Project: IEEE P802.15 Working Group for Wireless Personal Area Networks (WPANs)

Submission Title: [**Comment resolution on sensitivity definition and frame length field**]

Re: [In response to comment on TG4g FSK draft]

Abstract: [SFF comment resolutions]

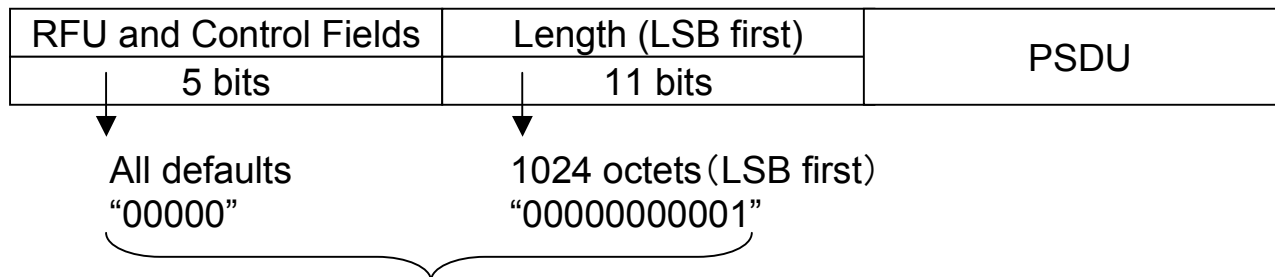
Comment: Proposed text (from SFF) below is missing;
"In the case of the MRFSK PHY, the Frame Length field shall be formatted with the MSB to be transmitted first."

- add "In the case of the MRFSK PHY, the Frame Length field shall be formatted with the MSB to be transmitted first."

- Average number of consecutive zeros or ones are smaller (next slide)
- PHR will be formatted in octet-wise in practical implementation
 - 11 bit frame length field will be split into 2 octet fields
 - It seems reasonable 3 bits represents more significant bits (in the first octet) and 8 bits represents less significant bits (in the second octet)

Back-up: Frame Length Field

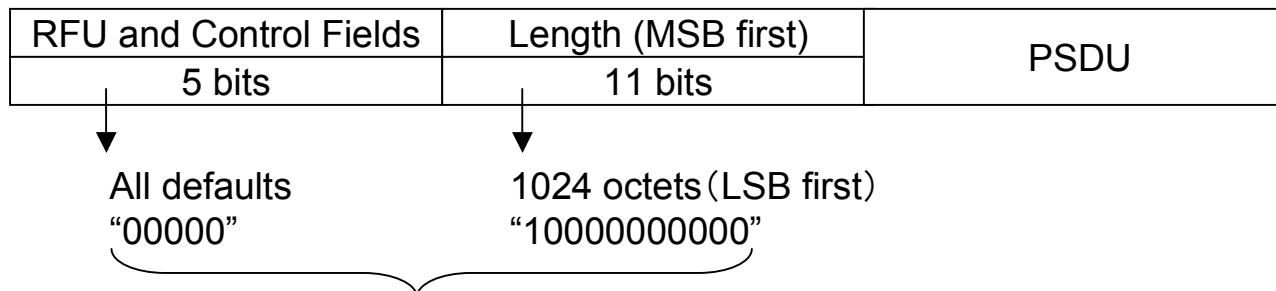
- Currently, PHR scrambling / non-scrambling is possible
- Should avoid transmitting / receiving continuous “0”s or “1”s, which could lead to bit error in FSK modem

15 bits of continuous “0”s -> should be avoided

10 bits of continuous “0”s

**-> average # of consecutive zeros will be smaller
as we do not have PSDU length of 0, ..., 4**
